LUFTDYKTIGHETSPÅBUD

RANGER

LUFTDYKTIGHETSPÅBUD (LDP)

**2003-044 KONTROLL/MODIFIKASJON AV STEMPEL VED OVERHALING ELLER VED
INSTALLASJON AV NYE STEMPEL**

FIGURE 1

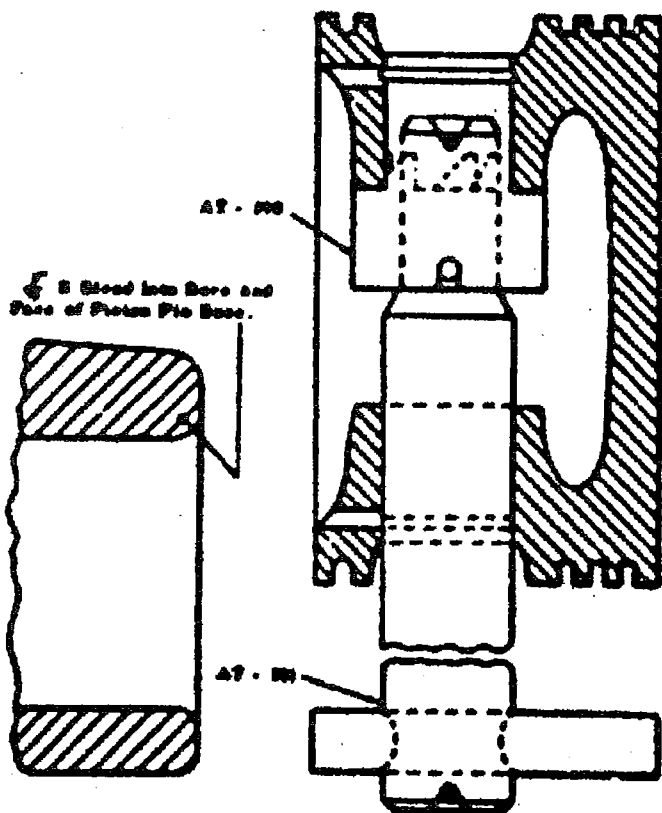
- (a) Inspect pistons by the fluorescent penetrant inspection method, or an equivalent, for cracks especially in areas around the piston pin boss and on the reinforcing web inside the piston. If cracks are found in these locations, the piston should be discarded.
- (b) Inspect pistons to ascertain if a 3/32-inch radius has been added at the inner ends of the ID of the piston pin bosses. Pistons which do not incorporate this radius should be modified as shown in **Figure 1** in order to relieve stress concentrations. Pistons with cracks in this location which cannot be removed by the following modification should be discarded also.

After thoroughly cleaning the piston, place it head down on the bench; insert cutter No. AT-390, or an equivalent, between the piston pin bosses, facing in the direction of the boss to be cut. Insert handle No. AT-391, or an equivalent, through the opposite boss and engage with cutter. Cut radius by rotating cutter in a clockwise direction until the outer end of the 3/32-inch radius blends into the surface at the end of the piston pin boss.

Repeat this procedure for the opposite piston pin boss.
